HN-226.1  
DN-172.1  
EN-63.1  
FN-51.1

# SERVICE BULLETIN

**SUBJECT:** ONE-TIME INSTALLATION OF 369D24054-3 WARNING DECALS IN THE ENGINE COMPARTMENT AREA

Figure 1. Engine Compartment Warning Decal Installation.

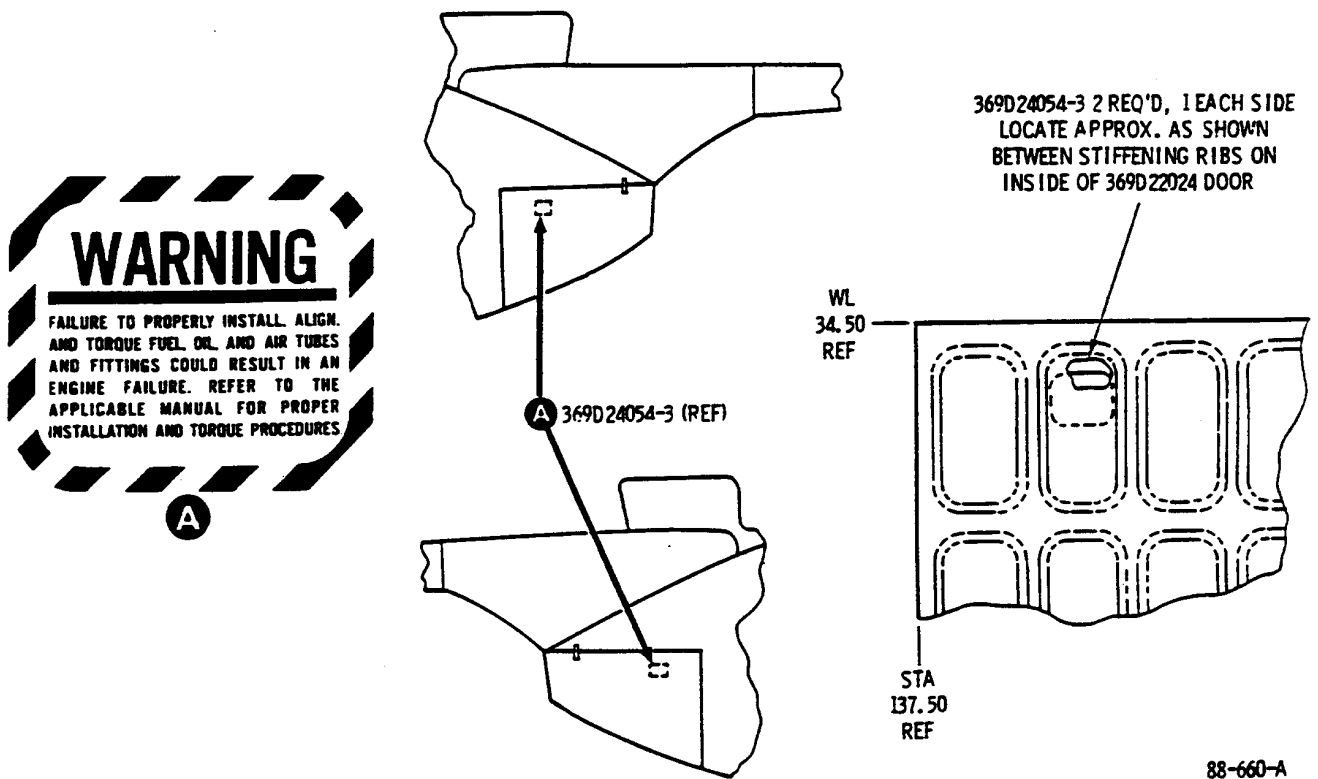
- a. Gain access to inside of the engine compartment.
- b. Verify that 369D24054-3 warning decals are installed as shown in Figure 1. If warning decals are installed, no further action is required.
- c. Ensure surface where decals are going to be installed is clean and free of oil prior to installation. Install warning decals at locations shown in Figure 1.
- d. Secure engine access door.
